NEW FLOOR PLAN

REV.	DESC./DATE
1	Field changes 10/01/03
<p><b>KCL Associates Inc.</b>            181 Goodwin Drive, San Bruno, Ca. 94066            Phone: 650/358-3011 Fax: 650/788-9414</p>	
<p><b>KHADDER RESIDENCE</b>            215 HILLVIEW AVE            LOS ALTOS, CA.            AP# 170-26-025</p>	
PLAN	NEW FLOOR PLAN
DATE	082403
DRAWN BY	T.C.
SCALE	1/4"=10"
JOB	030611
SHEET NUMBER	A-3

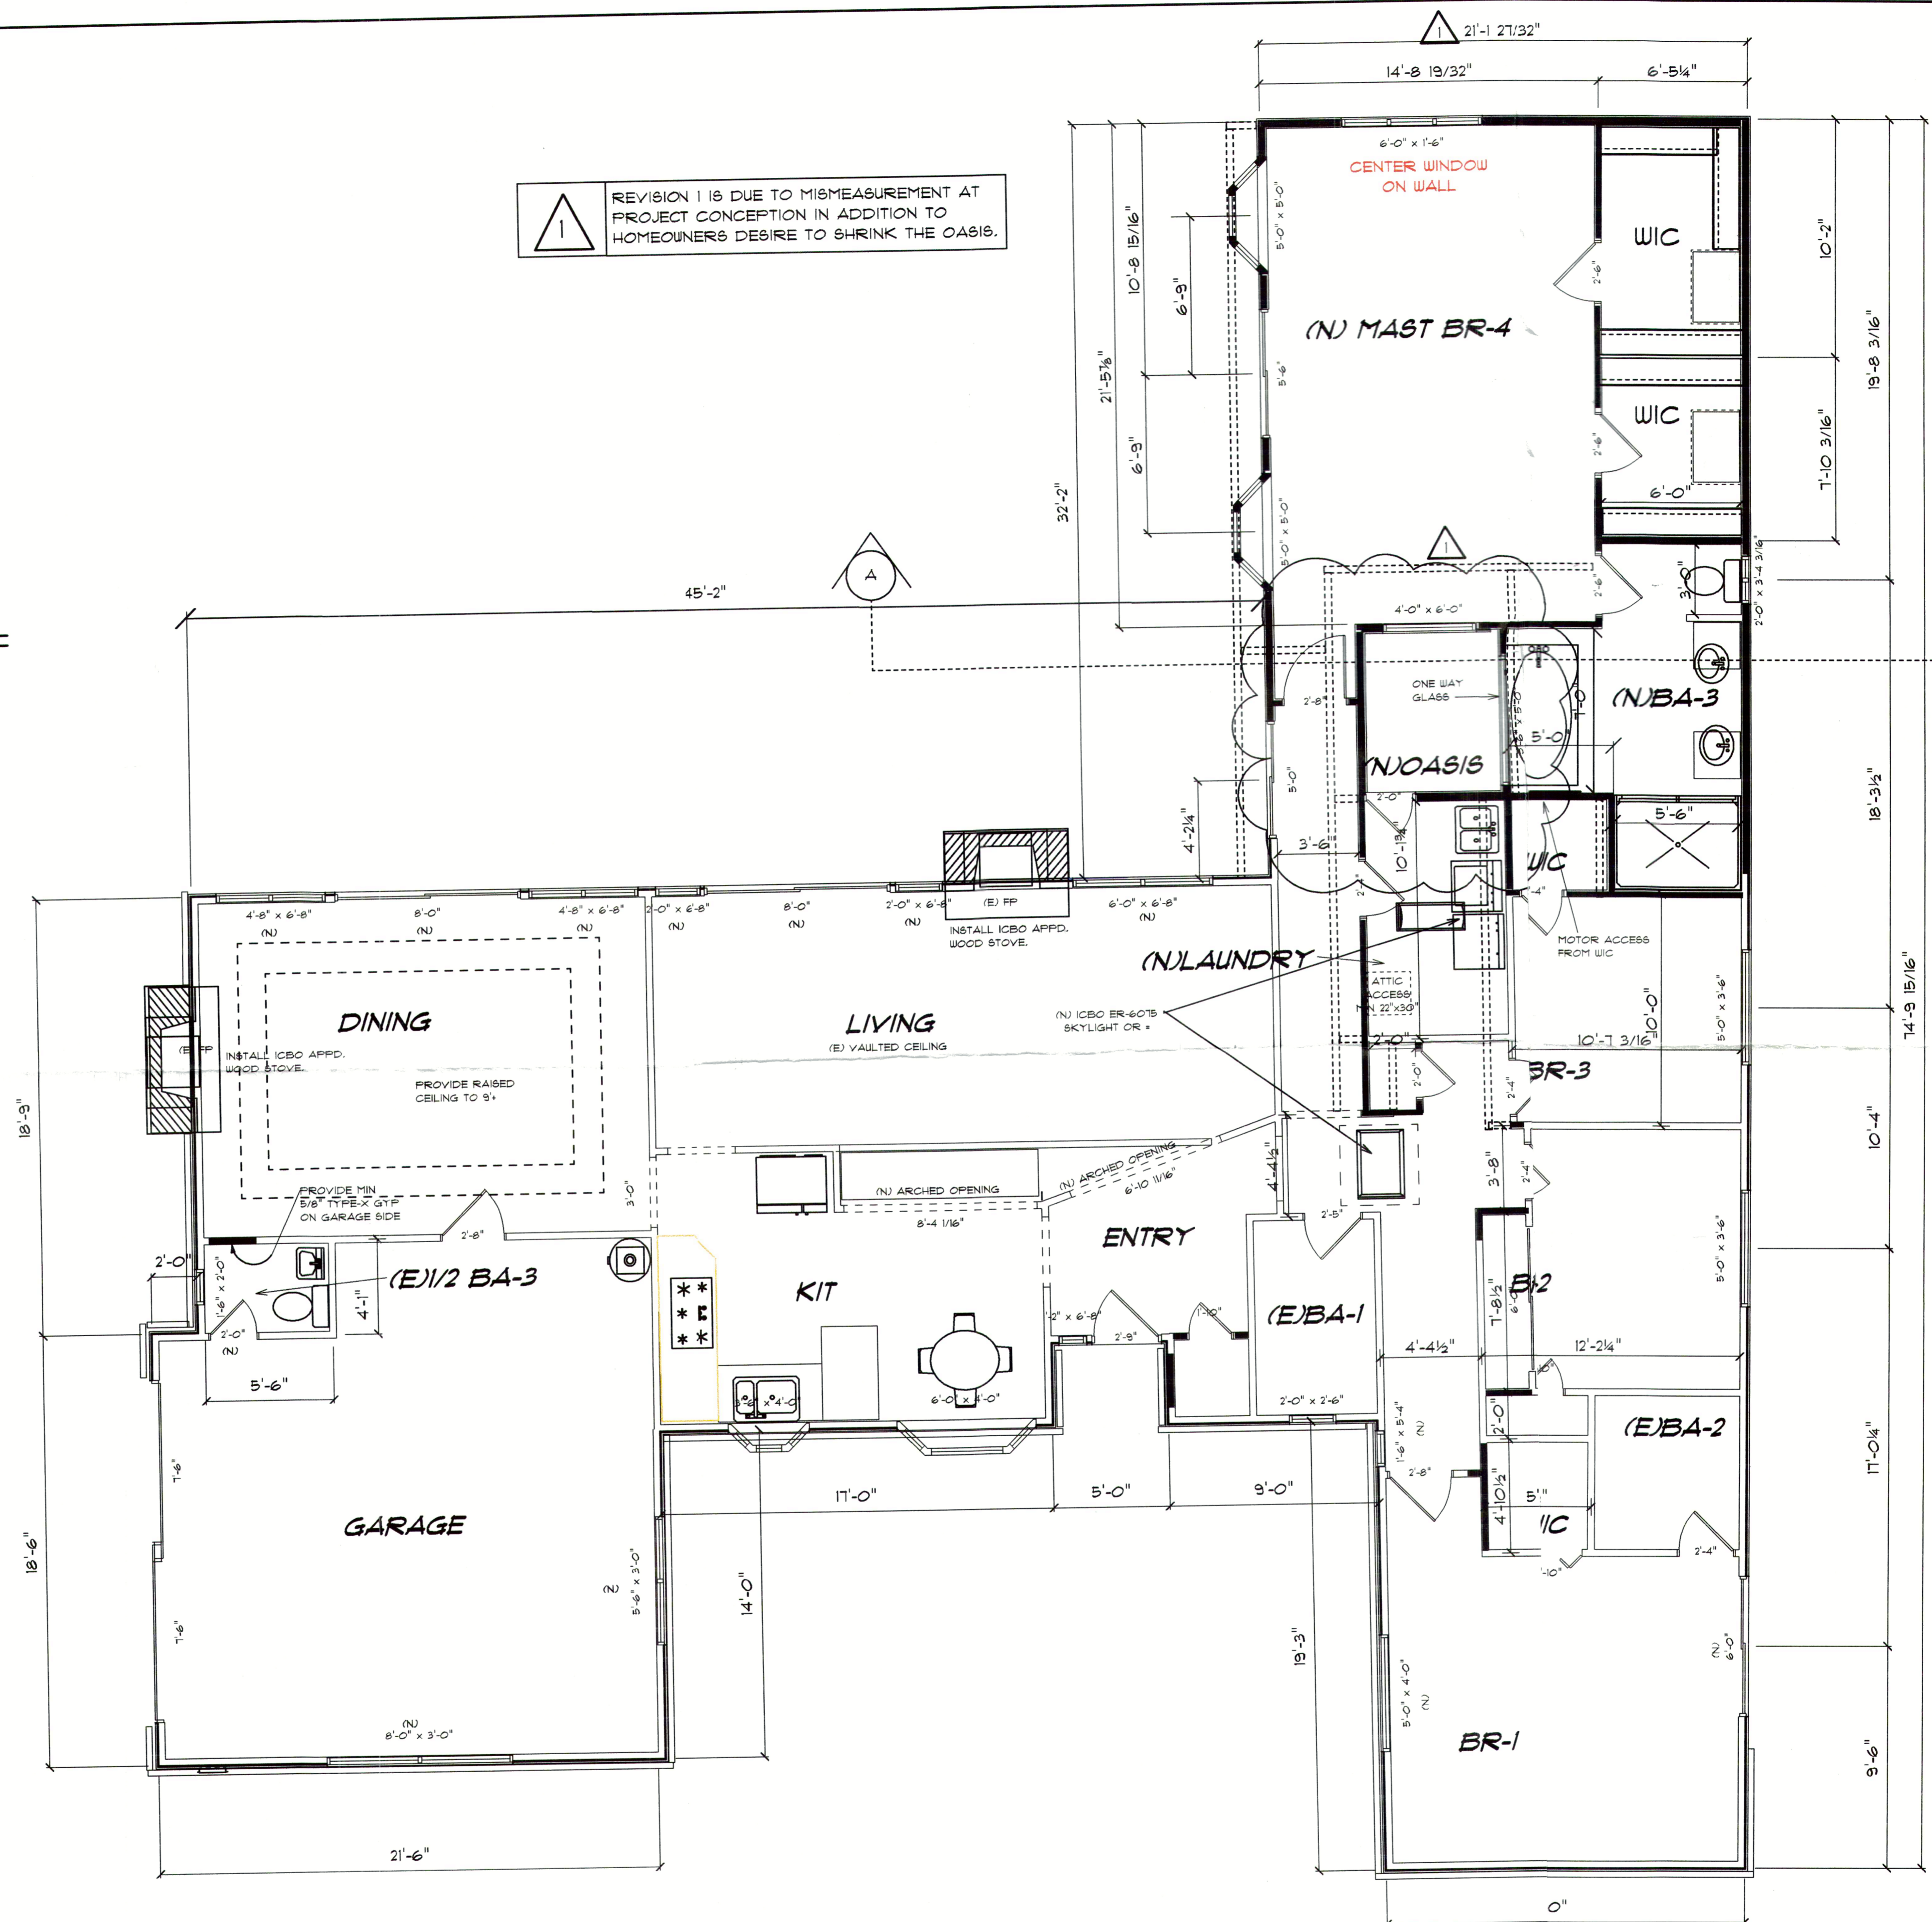
REVISION 1 IS DUE TO MISMEASUREMENT AT PROJECT CONCEPTION IN ADDITION TO HOMEOWNERS DESIRE TO SHRINK THE OASIS.
